Subject: MHI's Responses to US-APWR DCD RAI No.161-1812 Revision 0

Responses to Request for Additional Information No.161-1812
Revision 0

**US-APWR Design Certification
Mitsubishi Heavy Industries
Docket No. 52-021**

RAI NO.: NO. 161-1812 REVISION 0
SRP SECTION: 16 - TECHNICAL SPECIFICATIONS
APPLICATION SECTION: 16
DATE OF RAI ISSUE: 1/21/2009

Figure B 3.0-1
Configuration of Trains and Systems

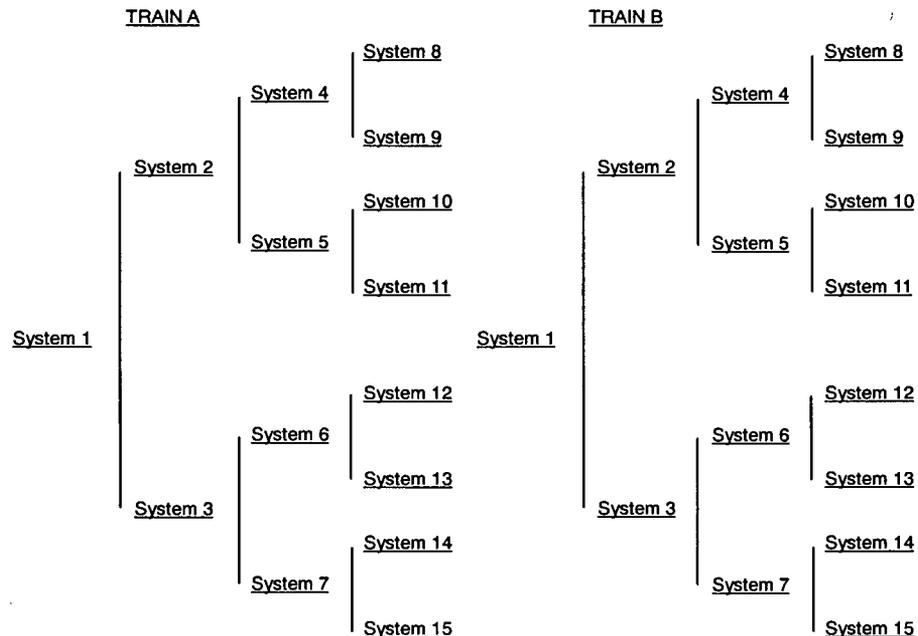
Provide examples of a loss of safety function related to cross train checks in the USAPWR TS LCO 3.0.6 BASES.

The related Bases will be revised as this RAI pointed out.

The DCD will be revised to include examples of a loss of safety function related to cross train checks as shown in Attachment 2.
